Determination 2015/051

Regarding the issue of a building consent for a 1-year-old house at 63 Kekerengu Valley Road, Clarence

This determination discusses the approach to be taken in assessing documentation provided in support of a building consent application, and whether the documentation provided in this instance was adequate in terms of the decision to grant consent. The determination also addresses amendments to the consent and the compliance achieved.

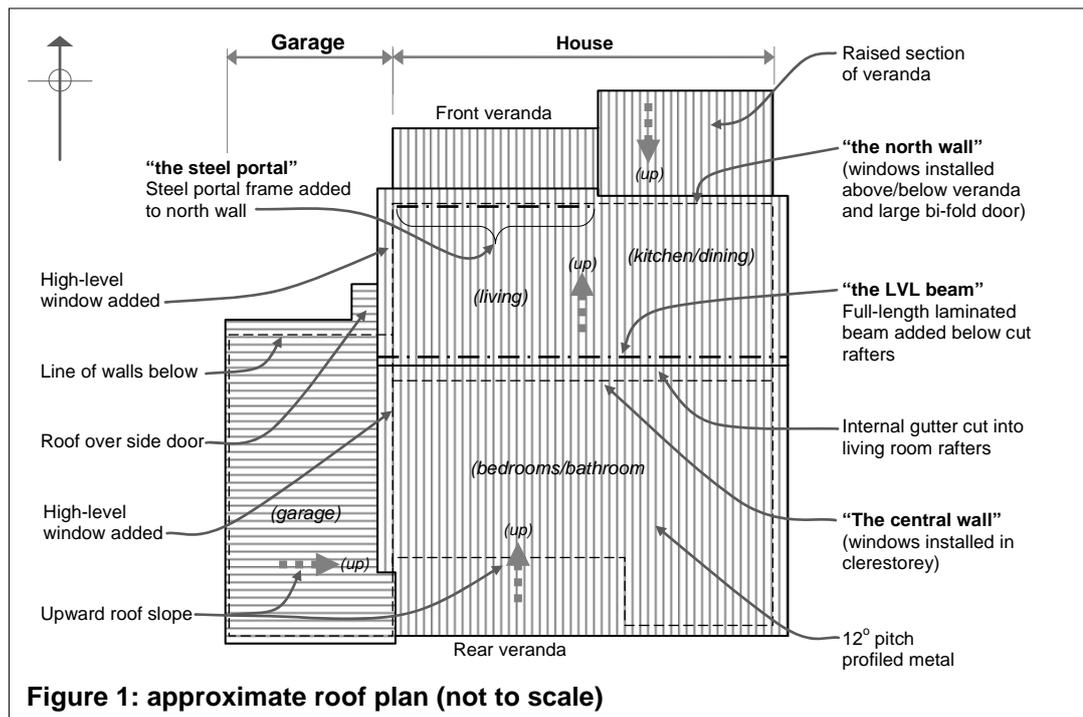
2.2 As shown in Figure 1 (over page), the building is made up of a number of attached monopitched roofs. The roofs slope up to form clerestorey walls, with high level windows and an internal gutter at the clerestorey to the south bedrooms. A lean-to entry veranda to the north includes a raised section above the eastern end and the south roof extends above a rear veranda, with both verandas supported on timber poles.
